Access Compliance Report

Public Rights-of-Way

Intersection ID: 30542	Main Street: AMBERWOOD_CT	Cross Street: SUMMERHILL_RIDGE_DR	Location: SW
ADA ID: 0AE8FFE52079	Ramp Type: PerpDiag	Initial Pass/Fail: Fail	Overall Compliance: No
Severity Score: 25			
Codes/Mitigation Info/Possible Solution		Field Measurements/Component Compliance

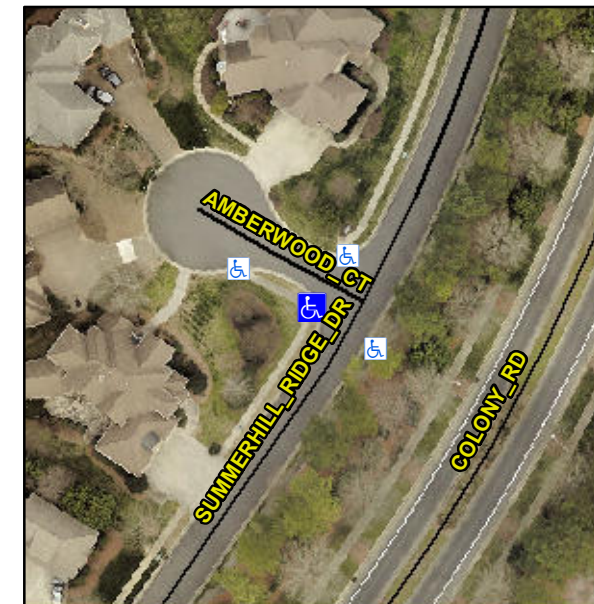
R304.5.3

Compliance	Description	Data	Compliance	Description	Data
N/A	Ramp Length (in)	47.0	Yes	Ramp Slope (%)	7.6
Yes	Ramp Width (in)	51.5	No	Ramp XSlope (%)	7.3
N/A	Flare Type LT	N/A	N/A	Flare Type RT	N/A
N/A	Flare Slope LT (%)	N/A	N/A	Flare Slope RT (%)	N/A
N/A	Flare Traversable LT?	N/A	N/A	Flare Traversable RT?	N/A
N/A	Landing Length (in)	N/A	N/A	DWS Provided?	N/A
N/A	Landing Width (in)	N/A	N/A	DWS Contrast?	N/A
N/A	Landing Slope (%)	N/A	N/A	DWS Length (in)	N/A
N/A	Landing X Slope (%)	N/A	N/A	DWS Full Width?	N/A
N/A	Landing Curb? (Y/N)	N/A	N/A	DWS Offset (in)	N/A
N/A	Shared Landing?	N/A			
N/A	Gutter Ponding?	N/A	N/A	Gutter Slope (%)	N/A
N/A	Gutter Lip Ht (in)	N/A	N/A	Gutter X Slope (%)	N/A
N/A	Painted X Walk1?	No	N/A	Painted X Walk2?	No
	X Walk 1 Direction	To SE		X Walk 2 Direction	To NE
N/A	X Walk 1 Width (in)	N/A	N/A	X Walk 2 Width (in)	N/A
	X Walk 1 Slope (%)	4.5		X Walk 2 Slope (%)	0.4
	X Walk 1 X Slope (%)	0.8		X Walk 2 X Slope (%)	4.8

Remove & Replace Curb Ramp With Two New Directional Ramps or Equivalent.
